ARLINGTON COUNTY, VIRGINIA

**County Board Agenda Item
Meeting of May 14, 2022**

SUBJECT: U-3468-16-1 USE PERMIT AMENDMENT for a below-grade parking structure with a lighted synthetic turf field above; located at 1601 Wilson Blvd.; (RPC# 16-032-001).

Figure 8: APS Proposed 18th Street North Section

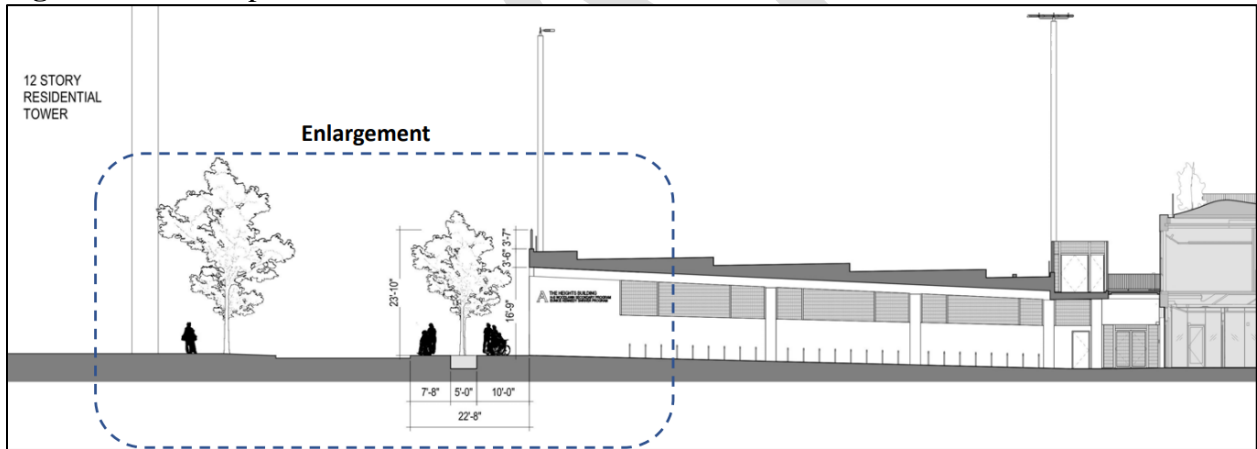
The applicant’s proposed 18th Street North segment is not consistent with the WRAP. The WRAP depicts a 39-foot-wide street to include an 11-foot travel lane in each direction, 7-feet of on-street parking on the north side of the street, and a 10-foot-wide bus parking lane along the south side of the street. The WRAP also depicts a 2.5-foot curb and lighting zone, a 10-foot-wide sidewalk, and an optional width for street trees along the back of sidewalk. The WRAP streetscape could support APS’s goal for a minimum 7-foot clear landing area by integrating street lighting with the poles used for field lighting at the back of sidewalk on the garage structure.

The County does not support the proposed narrowing of 18th Street North because it does not comply with the WRAP recommendations, and it could cause significant operational issues along the street, impacting APS proposed bus operations without otherwise prohibiting parking on the north side of the street. To prohibit parking on the north side of the street twice a day or more would limit the street’s public use to an extent not previously planned or contemplated. This will be discussed in more detail below as part of the discussion section. Staff recommends updating the APS proposal to be generally consistent with the WRAP streetscape and street cross section recommendations.

Arlington Public Schools agrees to maintain a street cross section of approximately 38 feet on 18th Street North including the retention of the parking lane on the south side of 18th Street North adjacent to the Arlington Public Schools property (originally approved as part of the Civil Engineering Plan per Condition #20.B.10) for the life of the use permit.

Figure 14: APS Parking Occupancy

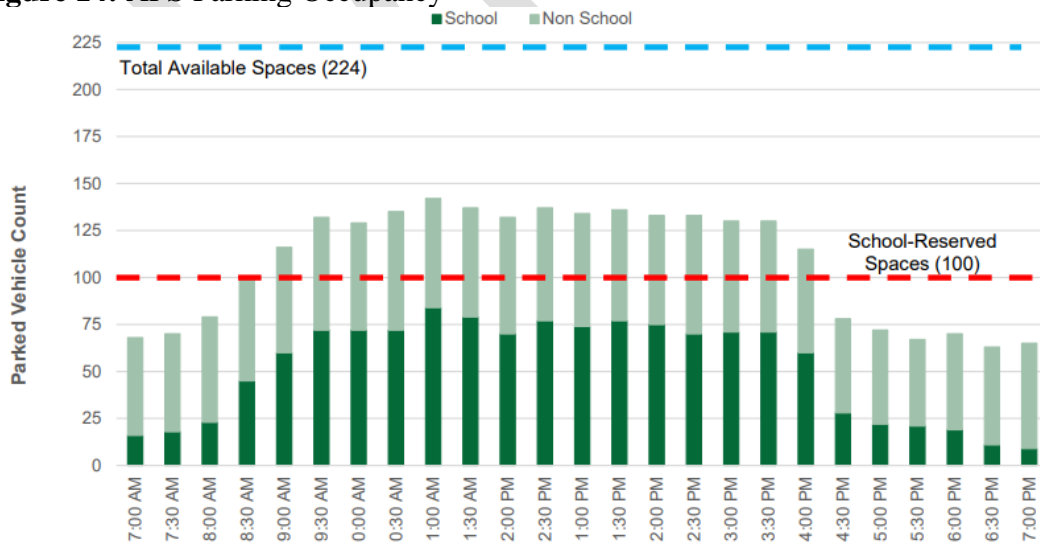
The MMTA data indicates in the Aubrey garage peak utilization occurred around 11:00 AM with 84% of APS spaces occupied. Overall, the data shows the Aubrey garage, during peak occupancy, had more than 75 unoccupied spaces throughout the garage. Assuming all 30 spaces in the 1776 Wilson Boulevard are fully utilized the data in the MMTA would suggest the parking demand for teachers/staff peaks at around 115 spaces.

The MMTA demonstrates that the proposed garage likely will provide more parking than the H-B or the Shriver programs demand and it shows that APS parking demands can likely be met in the Aubrey garage by utilizing otherwise under-utilized spaces. The MMTA also shows that ADA users of the Shriver program would be provided a higher level of service by parking in the garage below field when compared to parking in the Aubrey garage or on-street.

Figure 16: APS Proposed 18th Street North Operations

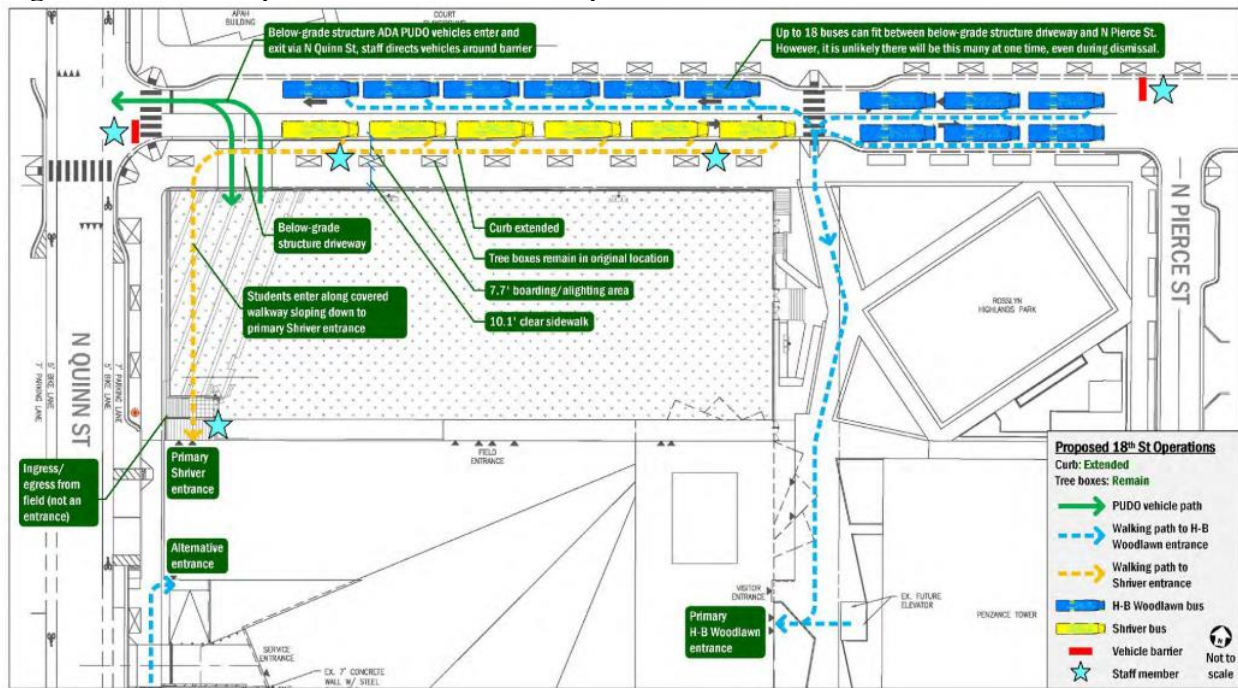
Staff’s review of APS’s 18th Street operations and design plan has identified two areas of concern along with recommendations to mitigate the concerns.

1. Removal of the parking lane along the school frontage will require removal of all vehicles along the northern parking lane for bus operations to work.
2. The proposed garage entrance increases operational challenges closing 18th Street North during arrival and departure while also permitting limited access into the garage.

By removing the parking lane along the south side of the street APS’s proposed bus operations would require parking to be removed from the north side of 18th Street North during morning arrival and afternoon dismissal periods. APS’s diagrams suggest that a minimum of 29-feet of street width is required to double stack APS buses and provide safe passage for students between buses. If vehicles remained in the parking lanes during prohibited periods those parked cars would have a significant impact on APS operations. Since the parking would need to be cleared twice daily, the opportunity for APS’s operations to be impacted could occur regularly. Additionally, to regularly ticket and tow vehicles multiple times a day could require a significant amount of policing resources that may not be regularly available.

Ultimately staff believes it would be unsustainable to allow public parking along the north side of the street during school days if the street is narrowed from 38-feet wide to 30.5-feet wide as proposed by APS through the removal of the southerly parking lane. This is not consistent with the WRAP recommendations for the 18th Street North Streetscape and Transportation Element, which include a parking lane along the south side of the street. Staff finds it critical to APS’s proposed operations that the parking lane on the south side of the street be provided. With the retention of the southern parking lane along the APS frontage, DES would support APS using

and controlling the southern parking lane weekdays during school operations. With APS exclusively using the southern parking lane it is less likely that vehicles remain parked in the lane during arrival and departure periods. This would keep the northern parking lane available to the public at all times.

Figure 18: APS Proposed (left) and Alternative (right) 18th Street North Section

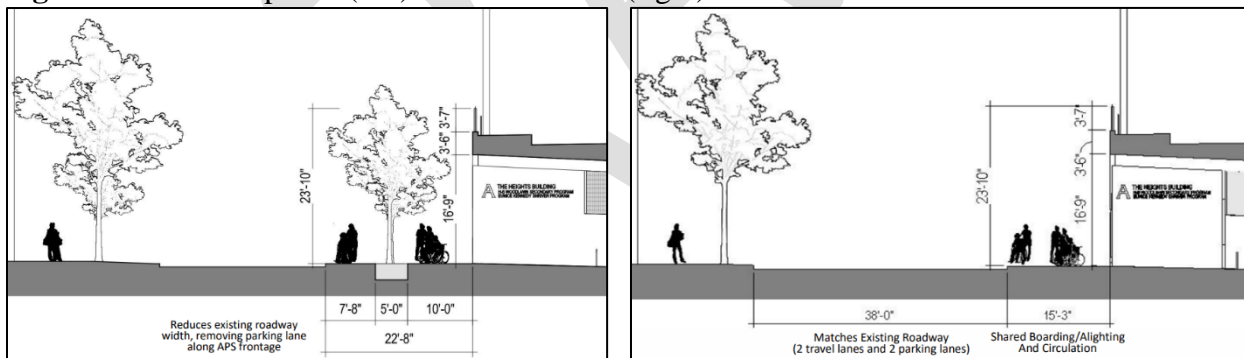
18th Street North Streetscape: APS proposes removal of the parking lane along the south side of 18th Street North adjacent to the school property. The area currently exists as a parking lane and would be incorporated into a revised streetscape proposed to be 22 feet 8 inches wide including a 7-foot 8-inch boarding/alighting zone, 5-foot tree zone, and 10-foot clear sidewalk.

As stated above, removing the parking lane is not consistent with the WRAP recommendations and raises operational concerns. If the parking lane along the south side of 18th Street North is to remain, the resulting streetscape width from the curb to the face of the parking structure would be 15 feet 3 inches which could include a 13-foot 3-inch combined boarding/alighting zone and clear sidewalk with a 2-foot-wide planter strip and seating along the parking structure wall. With this alternative streetscape proposed by staff, street trees would not be able to be accommodated

due to the space needed for bus operations including boarding, alighting, queuing, and circulation. This staff proposed alternative streetscape treatment along the APS frontage would support APS operational needs without narrowing 18th Street North.

Arlington Public Schools agrees to provide a minimum 15-foot 3-inch wide streetscape along the south side of 18th Street North adjacent to the Arlington Public Schools property (originally approved as part of the Civil Engineering Plan per Condition #20.B.8) to support Arlington Public Schools operational needs for the life of the use permit. The minimum 15-foot 3-inch-wide streetscape would include a 13-foot combined boarding/alighting zone and clear sidewalk with a 2-foot-wide planter strip and seating along the parking structure wall.

Figure 19: Field Elevation along 18th Street North

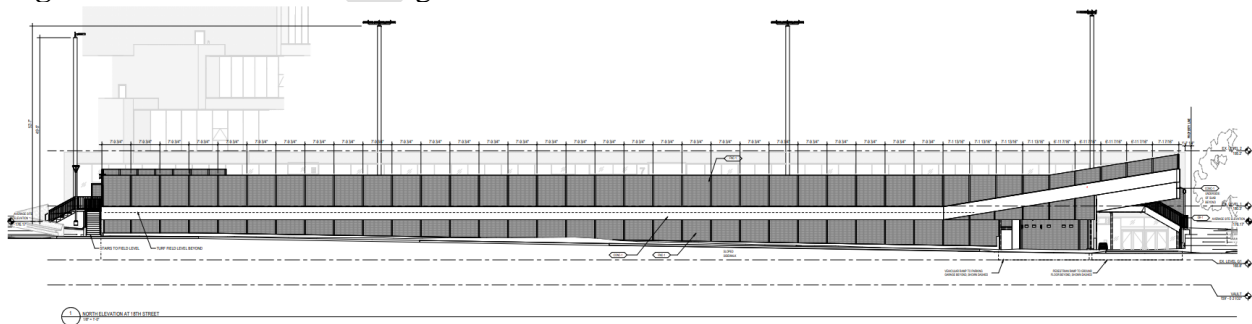
Field Elevation: APS proposes the field at an elevation of 180 feet, at grade with The Heights Building level 1 and Rosslyn Highlands Park at the southeast corner of the field. In 2017, APS proposed the field at an elevation of 175 feet. Lowering the proposed field elevation back to 175 feet, as proposed by staff, could provide many benefits to the site including an at-grade field access and visibility from the midpoint of the east field entrance to Rosslyn Highlands Park, an opportunity for an accessible entrance to the field from North Quinn Street providing improved access for students and the public, a less imposing wall along 18th Street North, improved conditions for street trees along 18th Street North, better visibility of the architecture of the school, and better natural lighting for Shriver Program classrooms at the ground level.

Arlington Public Schools agrees to construct the field elevation at a maximum of 175 feet to provide better integration into Rosslyn Highlands Park with at-grade field access and visibility from the midpoint of the east field entrance to the Park, an opportunity for an accessible entrance to the field from North Quinn Street providing improved access for students and the public, a less imposing wall along 18th Street North, improved conditions for street trees along 18th Street North, better visibility of the architecture of the school, and better lighting for Shriver Program classrooms at the ground level.
